## Submission:

### Chatswood Education Precinct (Upgrades to Chatswood Public School and Chatswood High School)

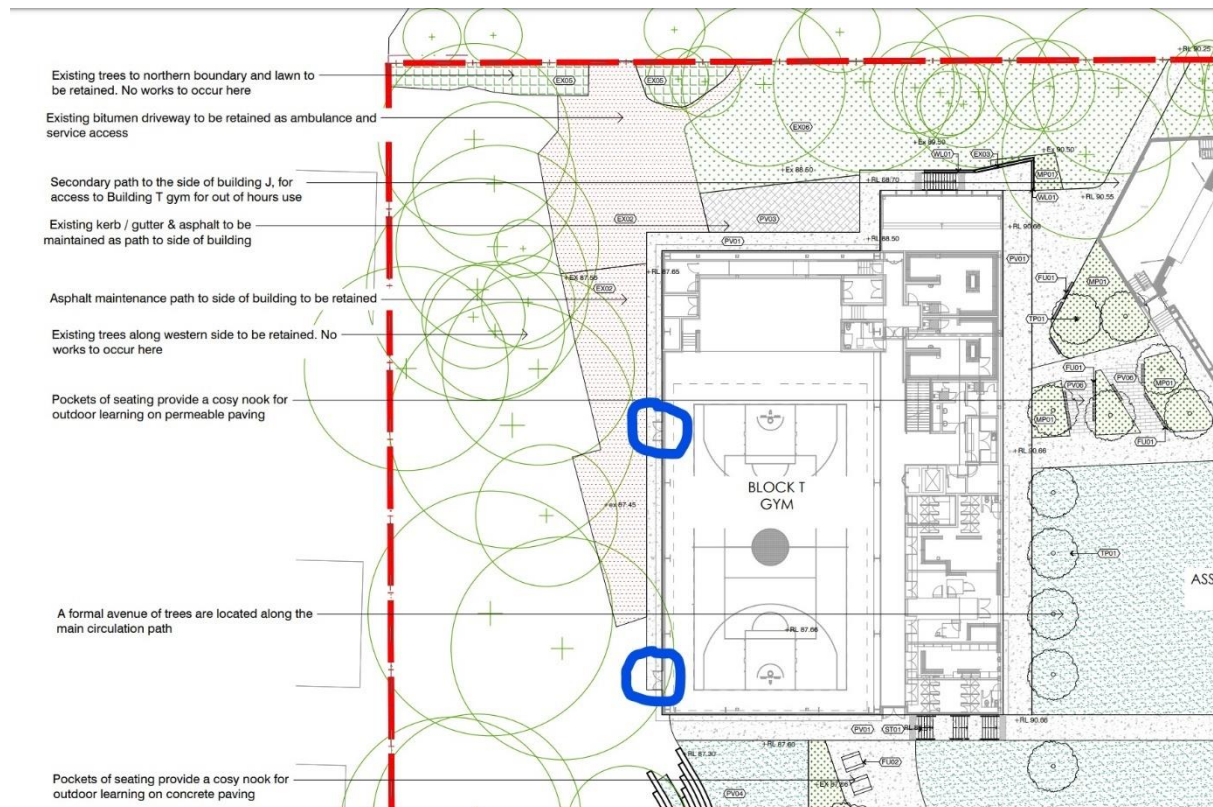
1. Two doors are opened on the west side of the Hall T overlooking the backyard and bedrooms of our house. The 2 doors are circled in blue on the plan below for your easy reference.

The Hall is a venue for school and community events such as sports, concerts, presentation nights and events opened to public. The two doors will allow access to the west side of the Hall T that overlooks our backyard and the bedrooms of our house. This will also increase noise. This will jeopardise our privacy and quiet enjoyment of our house.

2. We noted on the map "Asphalt maintenance path to side of building to be retained" on the west side of the Hall T. As the path to be retained on the west side of the Hall, the users of the Hall will be able to access and gather on the west side of the Hall that overlooks our backyard and bedrooms. Our privacy and quiet enjoyment of our house will be adversely affected.

- We request that the design to be revised to include appropriate screening along the path facing the west of the Hall T. The screening is to prevent negative impact on our privacy and quiet enjoyment of our property. The position of the screening suggested by us are drawn in yellow on the plan below for your easy reference.

- We request that the design be revised so that there will be no doors opened on the west side of the hall Block T, and the 2 doors proposed (as highlighted on the map above) to be removed. Alternatively, the doors to be opened on the other sides of the hall.
